FAWN GROVE AT SUNSET LAKES

an Addition to Wichita, Sedgwick County, Kansas

RE: SUB 2003-120 -- Final Plat of Fawn Grove at Sunset Lakes Addition

STAFF REPORT

FAWN GROVE AT SUNSET LAKES

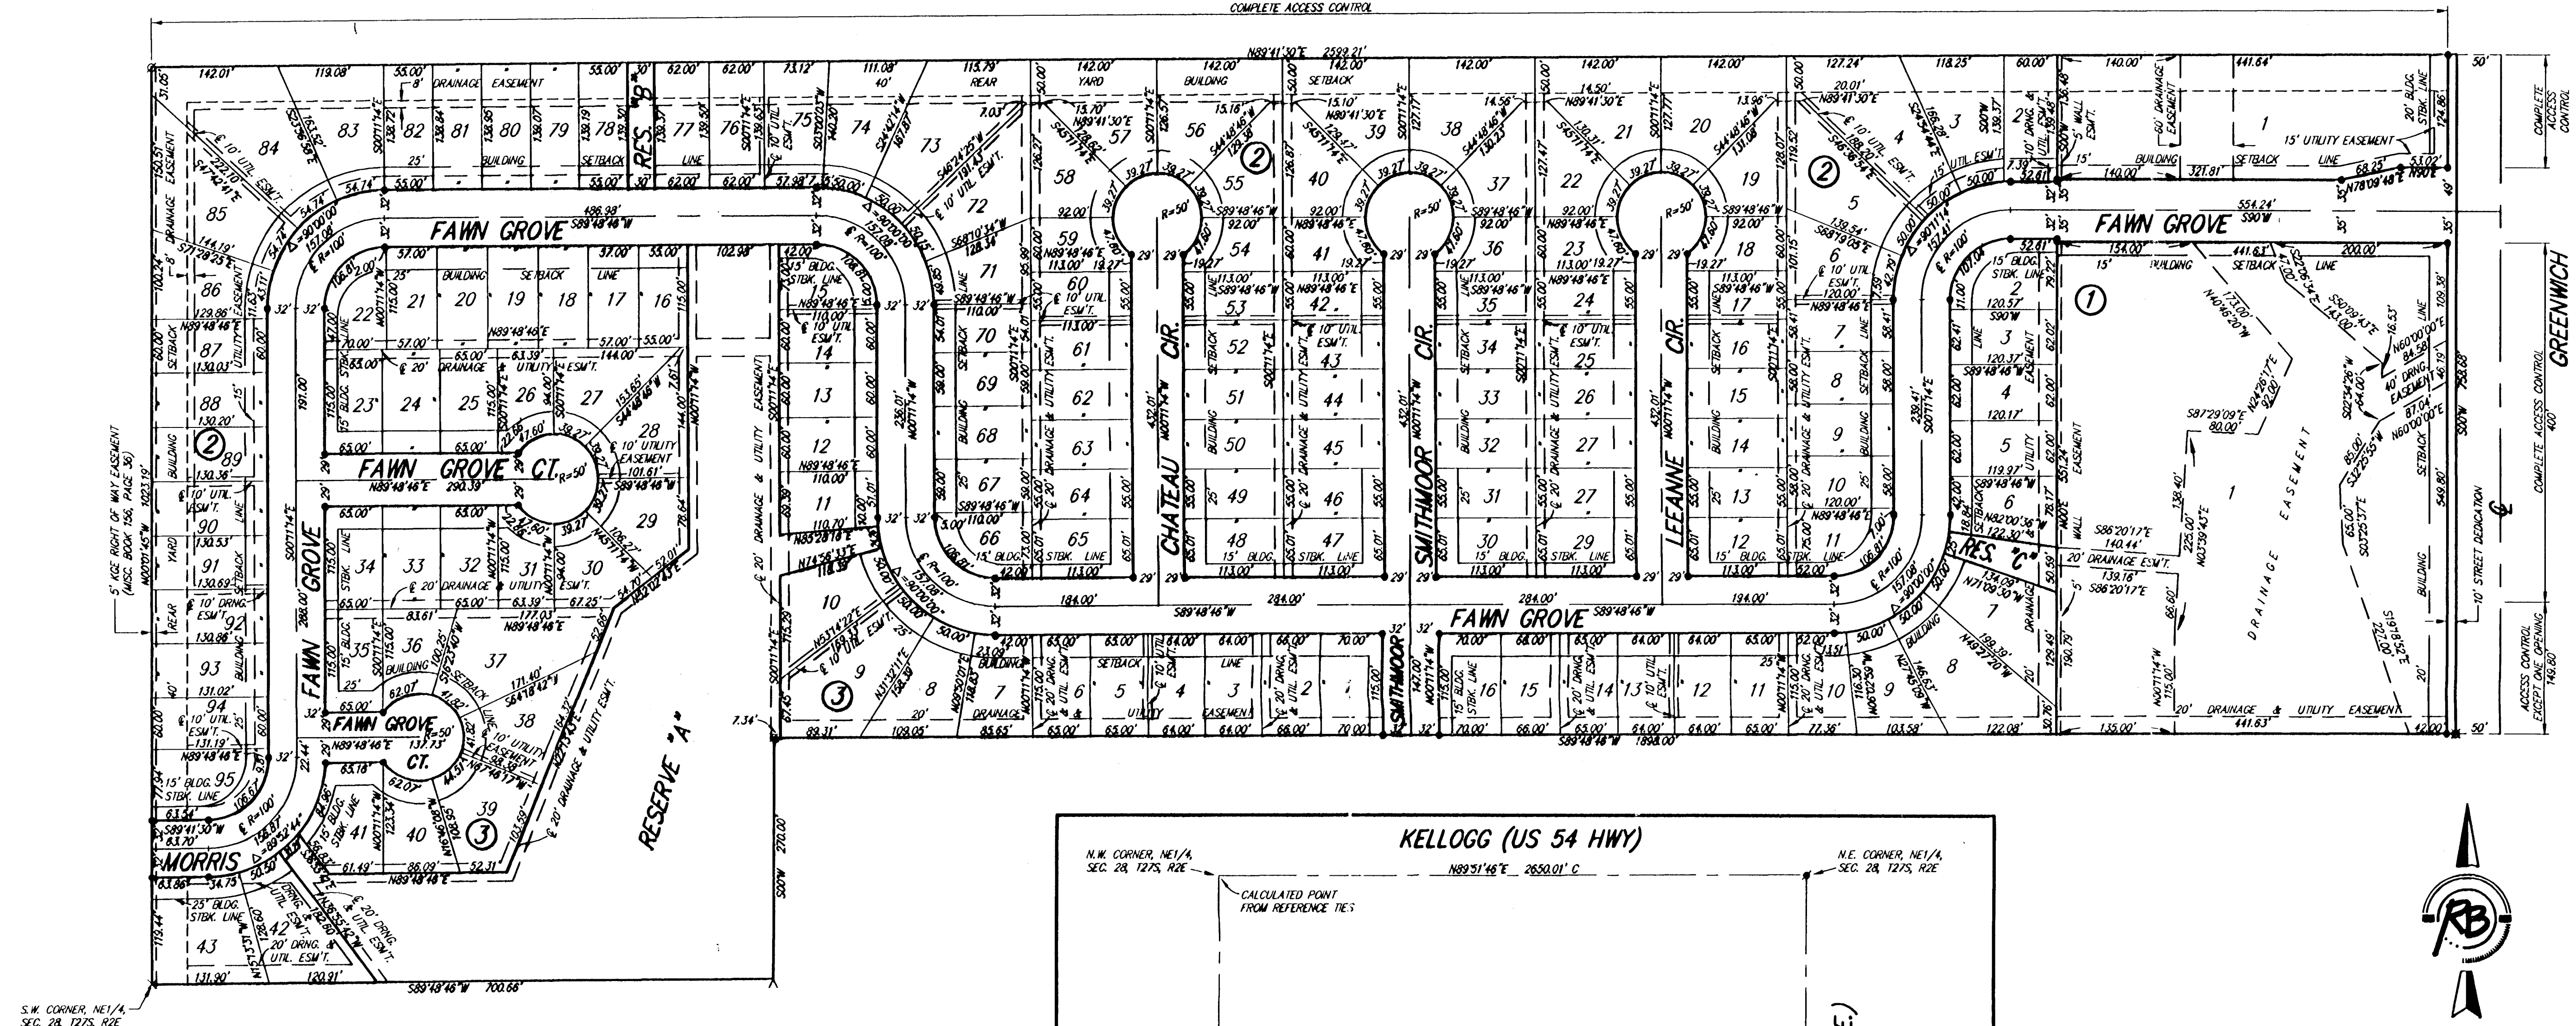
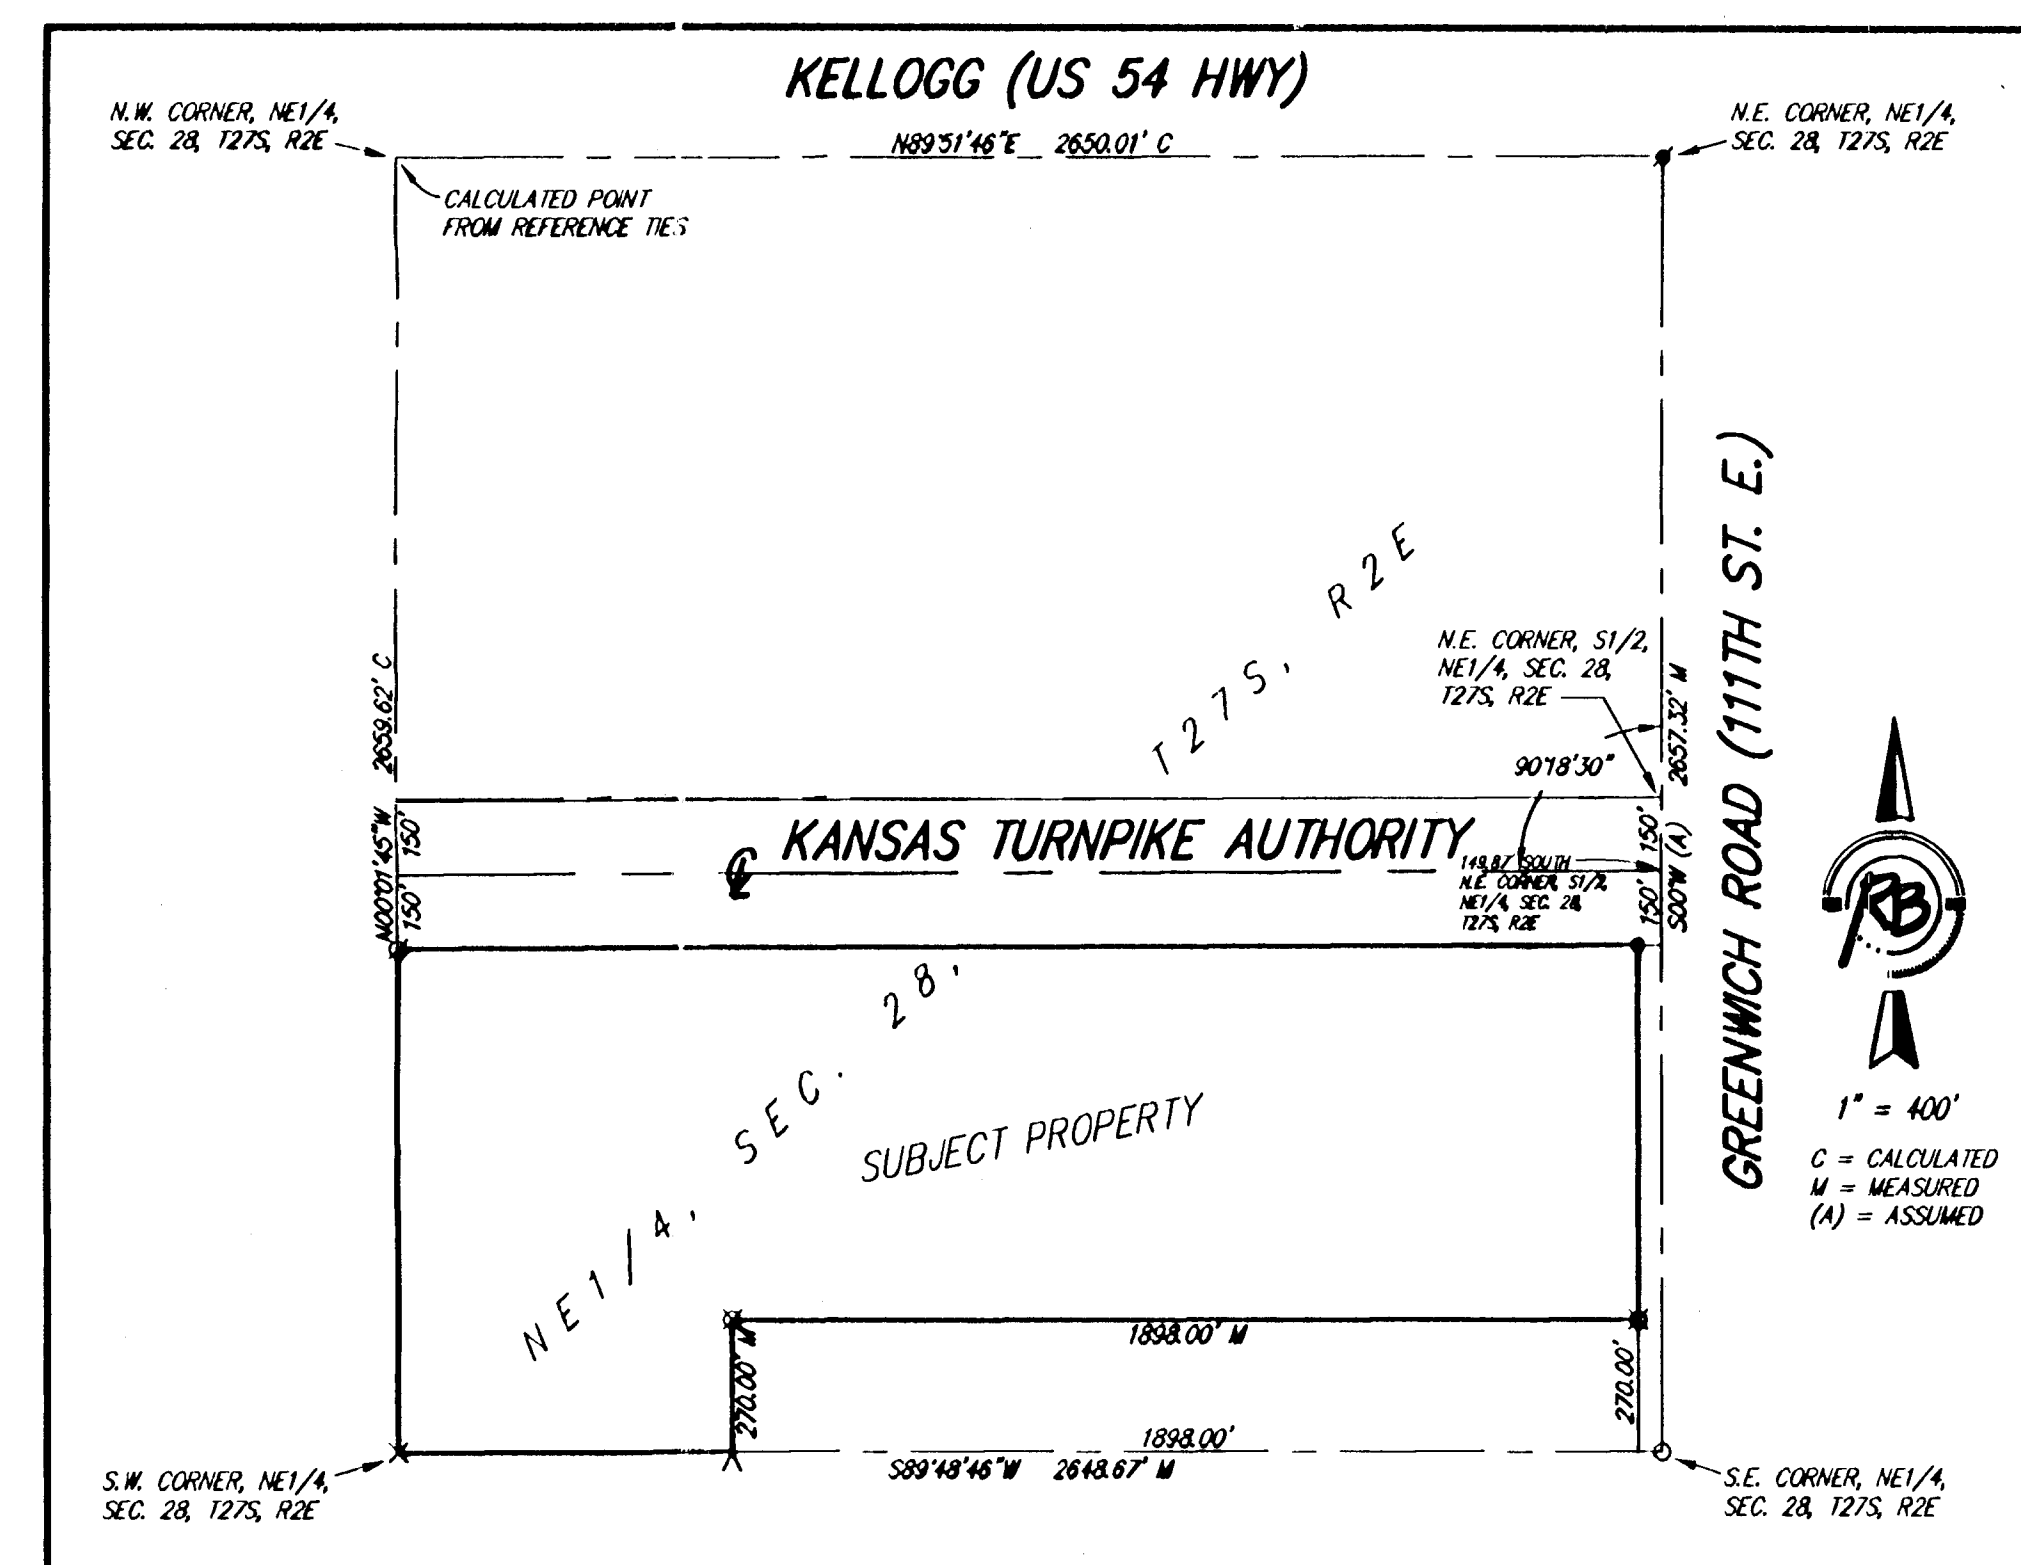
- A. This plat will be subject to approval of the associated zone change and any related conditions of such a change.
- B. The applicant shall guarantee the extension of sanitary sewer and City water to serve the lots being platted.
- C. If improvements are guaranteed by petition, a notarized certificate listing the petitions shall be submitted to the Planning Department for recording.
- D. City/County Engineering needs to comment on the status of the applicant's drainage plan. Stormwater Management has advised that the drainage plan must be in compliance with the drainage study currently being prepared for this area.
- E. The plat proposes one access opening along Greenwich. Access controls are approved.
- F. A 70-foot right-of-way for a commercial street is needed along Fawn Grove from Greenwich to the west line of Lot 1, Block 1 tapering to a 64-ft right-of-way.

- G. Traffic Engineering has requested the right-of-way width be increased to 64 feet for the street stub to the south.

- I. It is recommended that Reserve A be extended to the street by access easements or by narrow strips of Reserve between the lots to increase its accessibility and usefulness for all homeowners in the Addition.

- M. Block 1 west of Smithmoor should be labeled as Block 3.
- N. Traffic Engineering has requested a petition for left turn lanes.
- O. Morris does not line up with Morris as platted in Harrison Park 2nd Addition by 1.48 feet.

- M. Block 1 west of Smithmoor should be labeled as Block 3.
- N. Traffic Engineering has requested a petition for left turn lanes.
- O. Morris does not line up with Morris as platted in Harrison Park 2nd Addition by 1.48 feet.

The right-of-way has been platted as requested.

The right-of-way width has been platted as requested.

The Applicant has provided an additional connection from the street to the Reserve as requested.
